Transport Response to Section 92 Request

PREPARED FOR BAYSWATER MARINA HOLDINGS LIMITED | MAY 2021

**BAYSWATER MARINA HOLDINGS LIMITED
BAYSWATER MARITIME PRECINCT TRANSPORTATION ASSESSMENT – TRANSPORT RESPONSE TO
S92 REQUEST**

Following submission of the resource consent application (BUN60373319 dated 15 April 2021) for the above development, Auckland Council have issued a request for further information under Section 92 of the Resource Management Act 1991 (**s92 request**). The following responses address Transport related matters within the s92 request. These queries are cited in italics for ease of reference and responded to below.

CAR TRACKING
 SHEET 1 OF 6

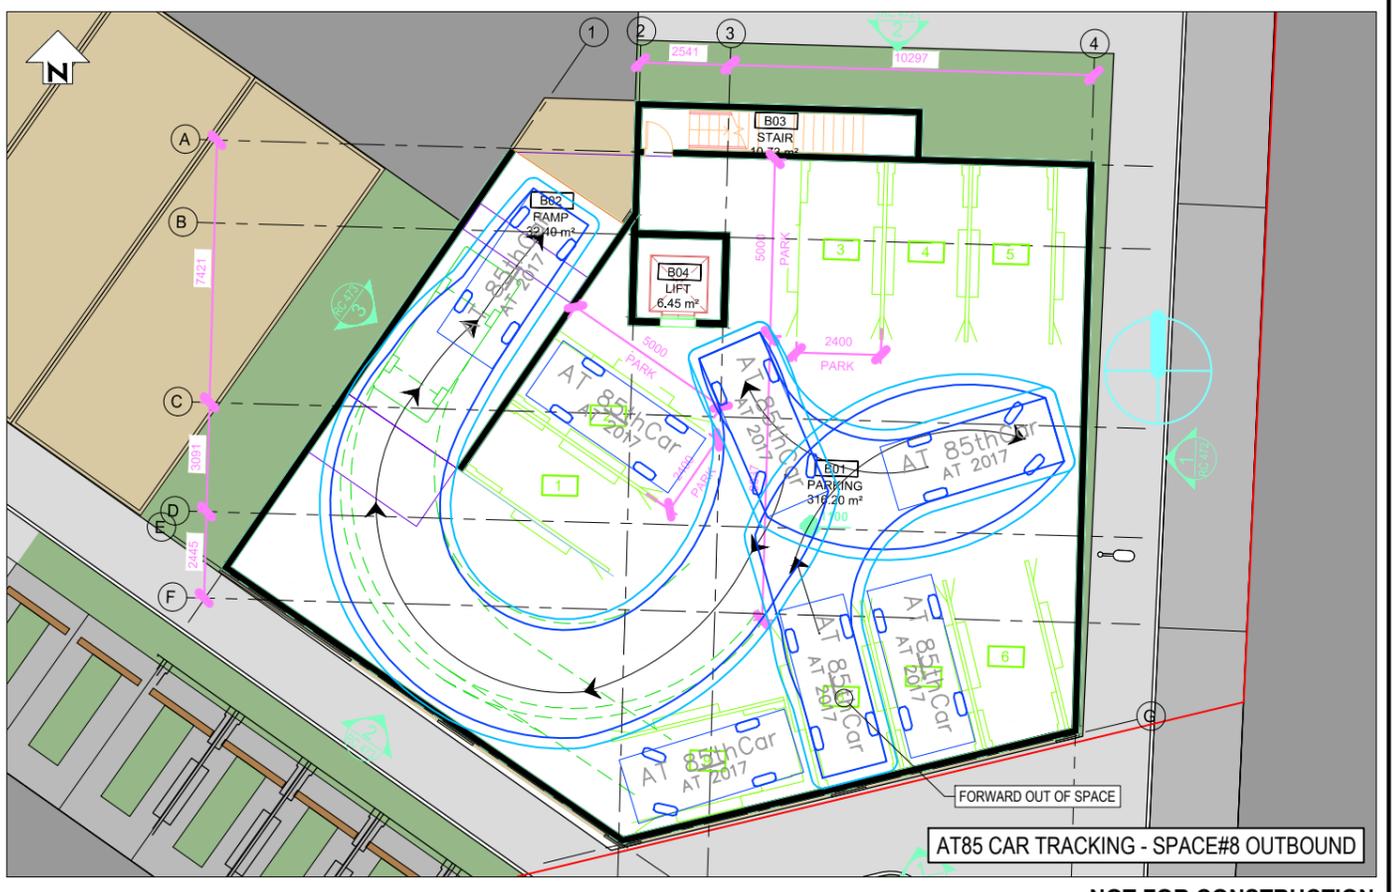
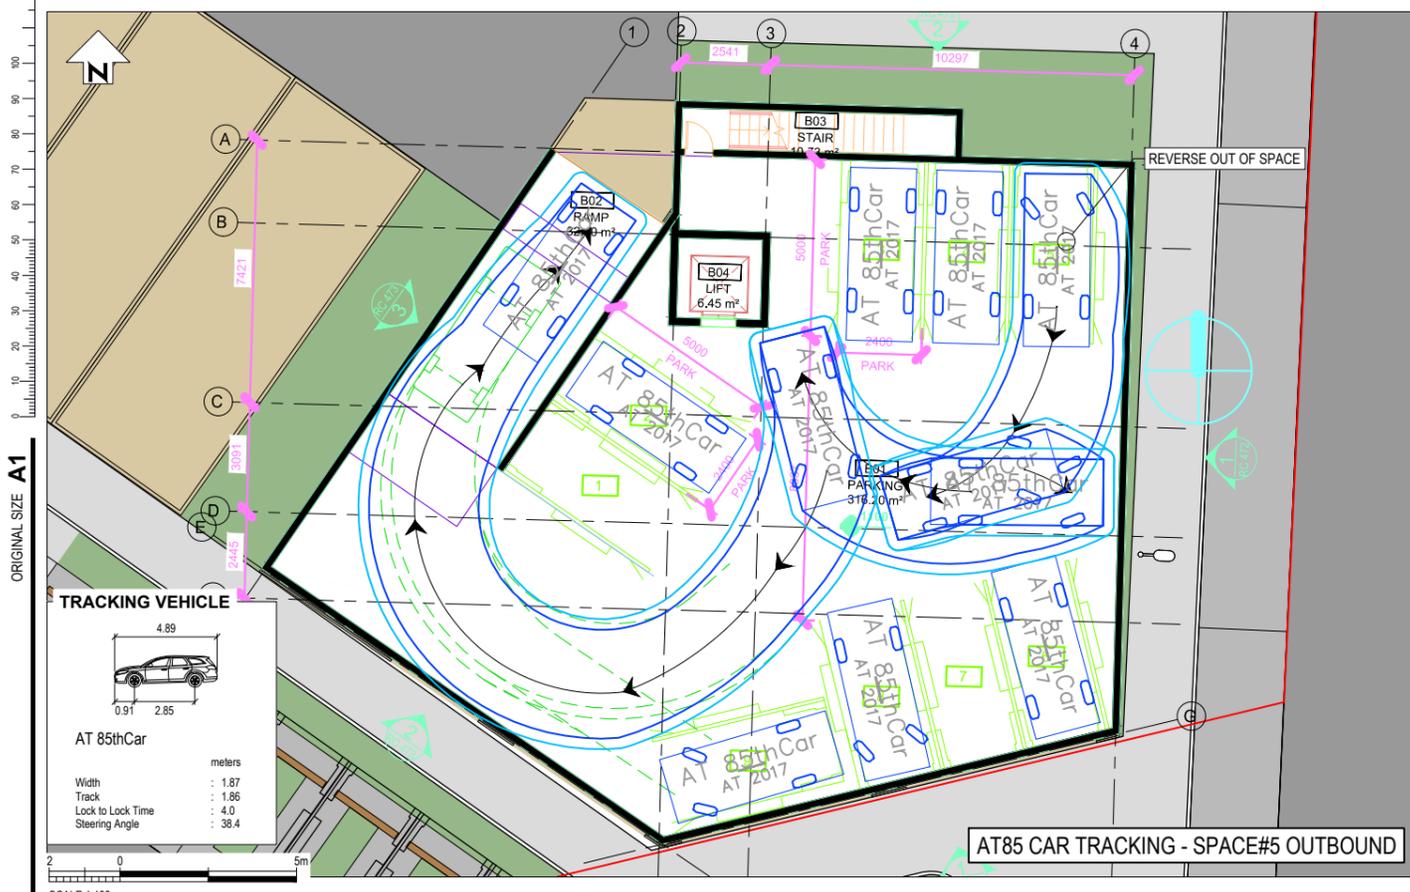
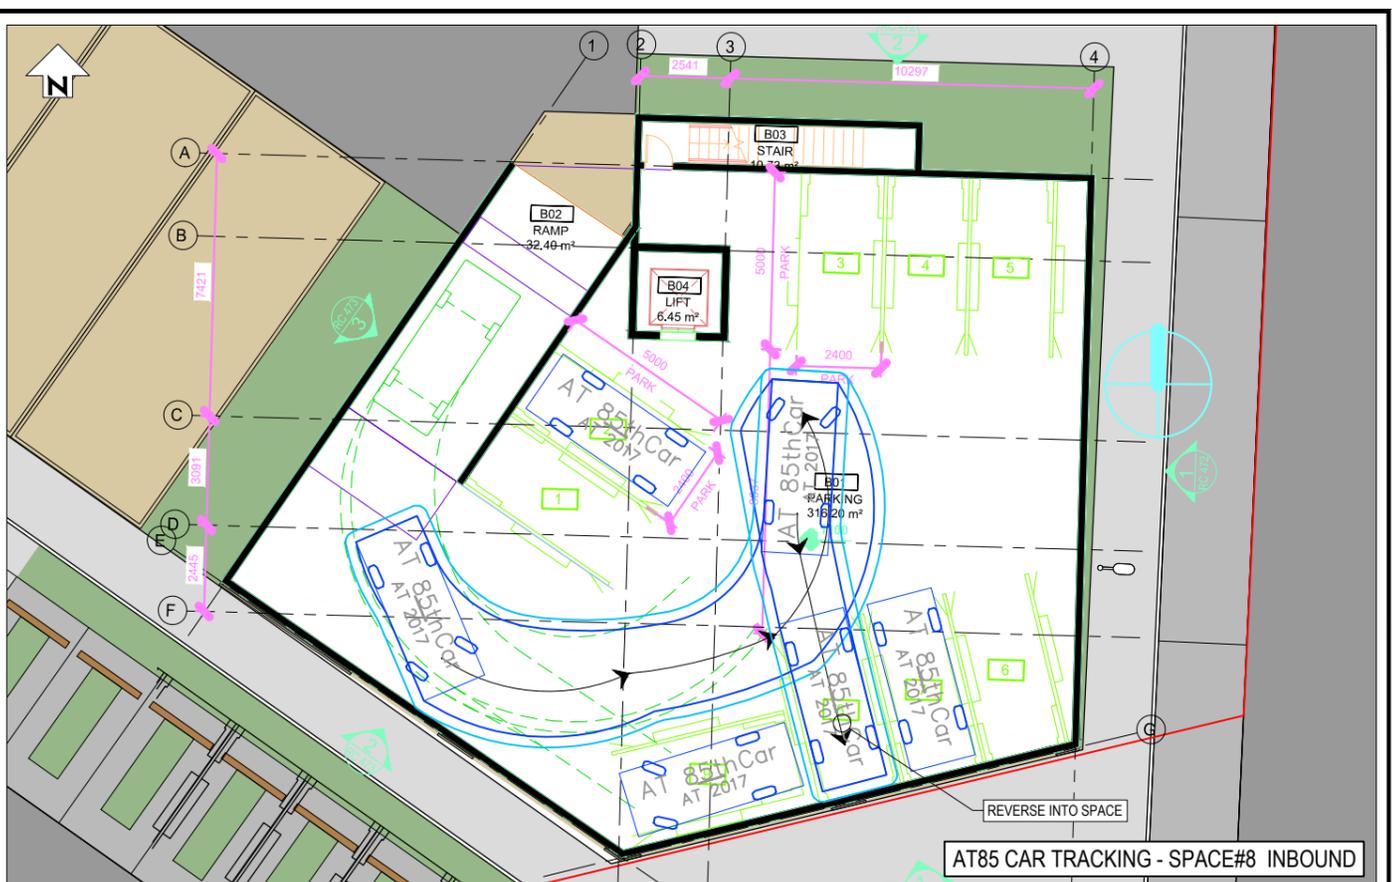
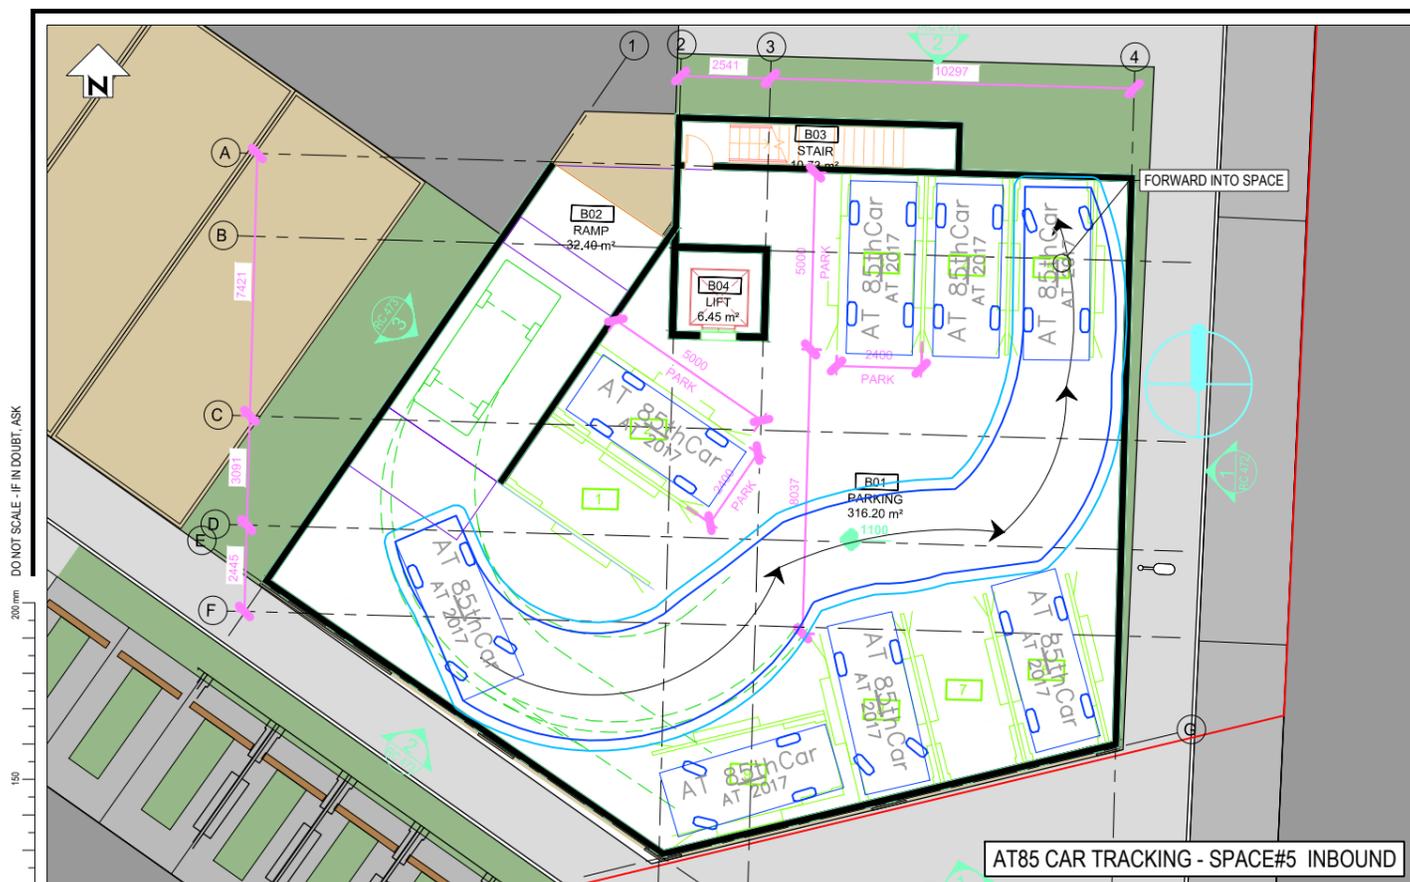
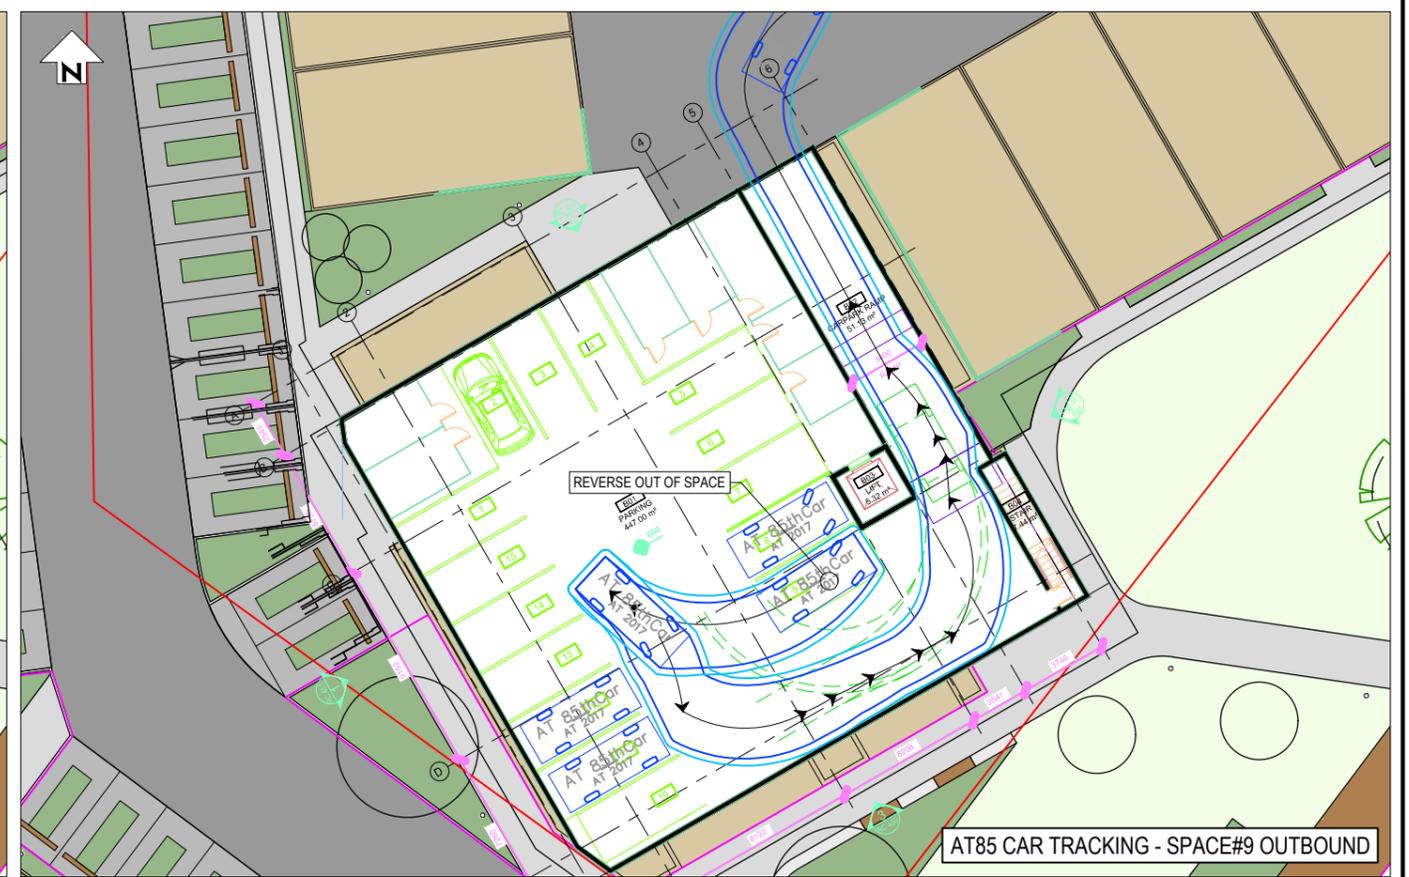
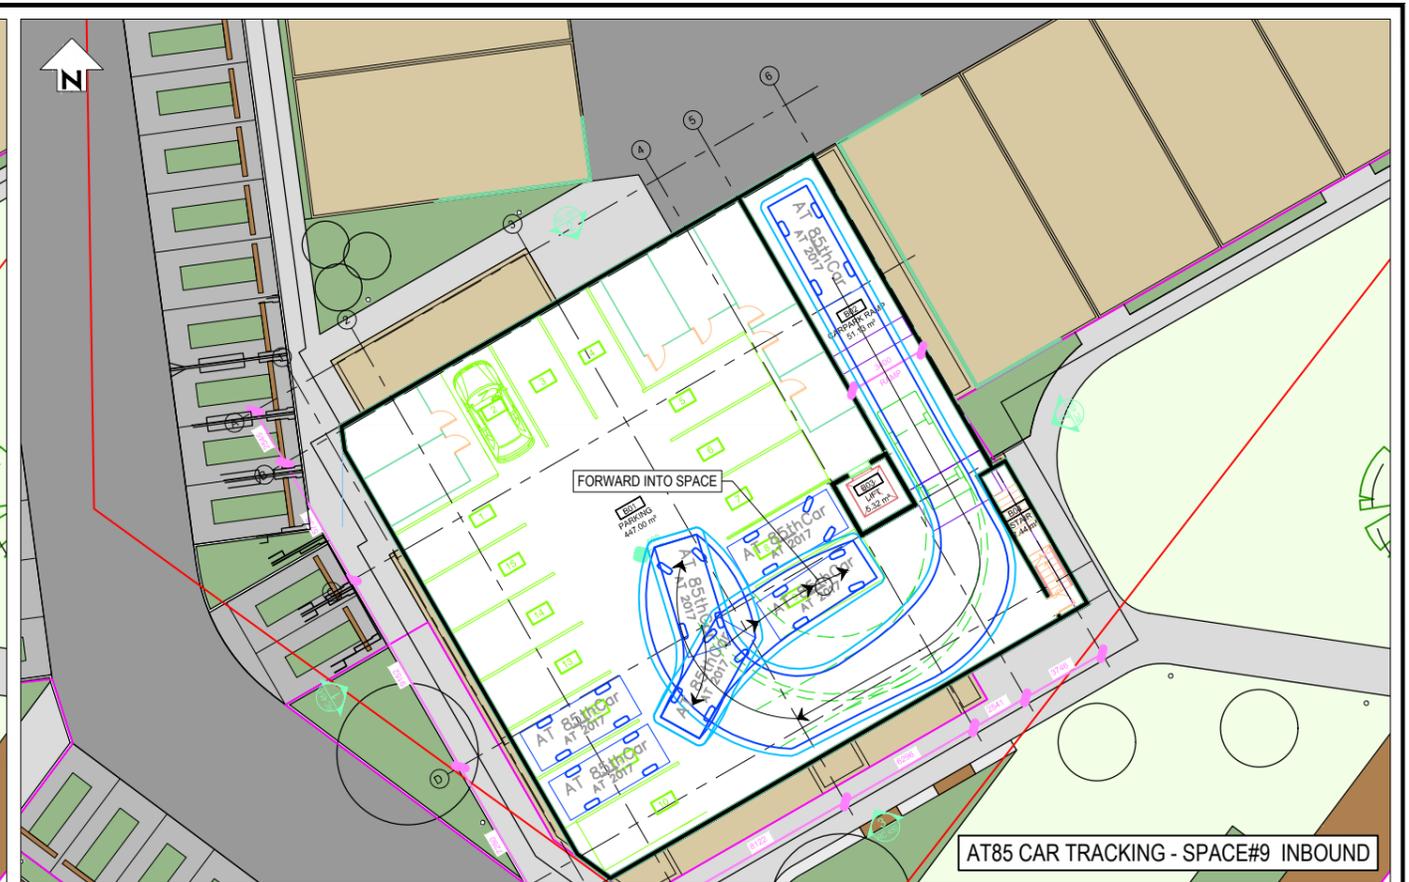
“Some of the parking spaces on level B01 of the apartment blocks look like they may have constrained manoeuvring area. Please show vehicle tracking for an 85th percentile car to demonstrate that the parking spaces work.”

Vehicle tracking has been undertaken for key parking spaces within the basement levels of the northern, central and southern buildings basements. The tracking diagrams are included in **Appendix B**.

It is noted that multiple manoeuvres will be required in order to access some of the most constrained parking spaces. However, these spaces will be dedicated parking spaces used by regular users/residents. The proposed provision of turntables within the basement level will ensure that manoeuvring will be acceptable and matched to the use by regular users of these parking facilities.

VEHICLE RAMP SECTIONS | 300 ELEVATIONS & SECTIONS |

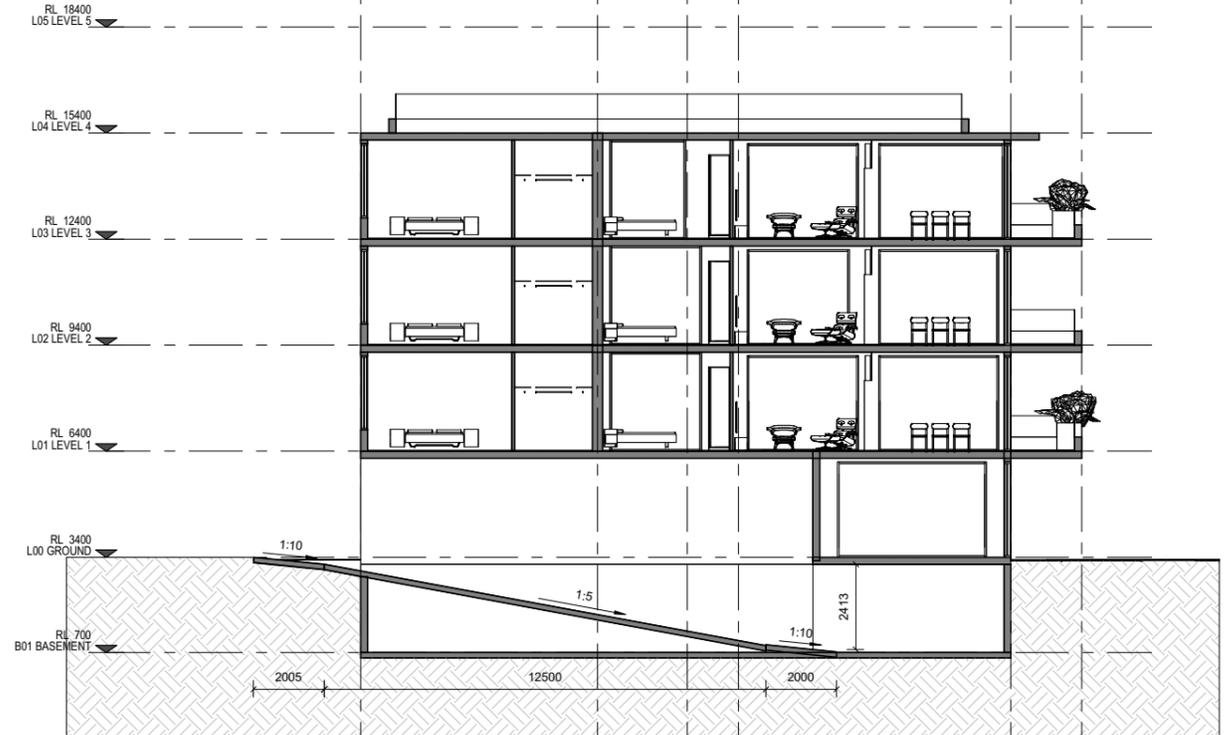
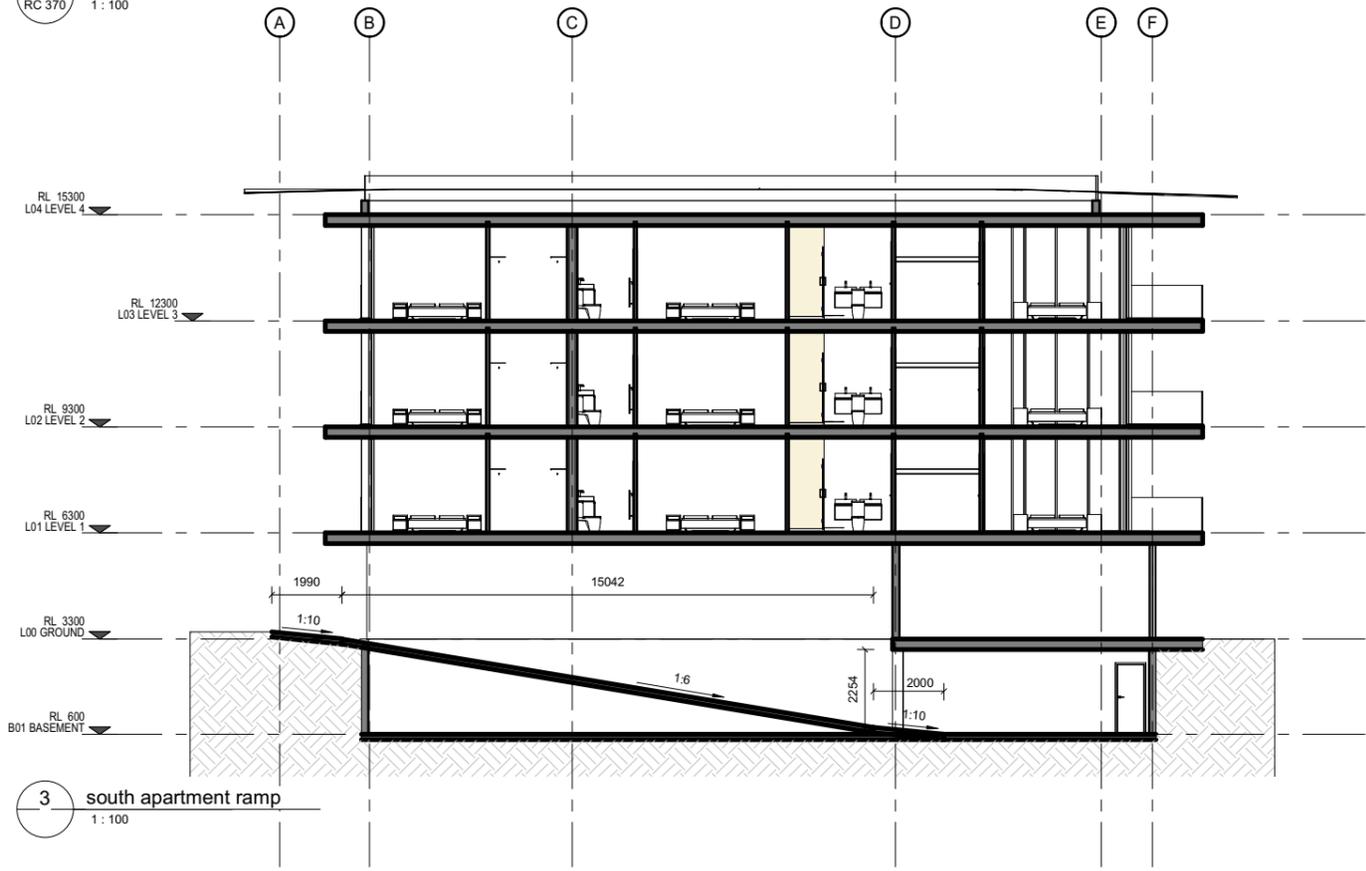
“Please provide more information on the access to the apartment buildings including, location, width, vertical clearance and ramp gradients.”

Refer to **Appendix C** included for longitudinal cross-sections of the basement car parking areas.
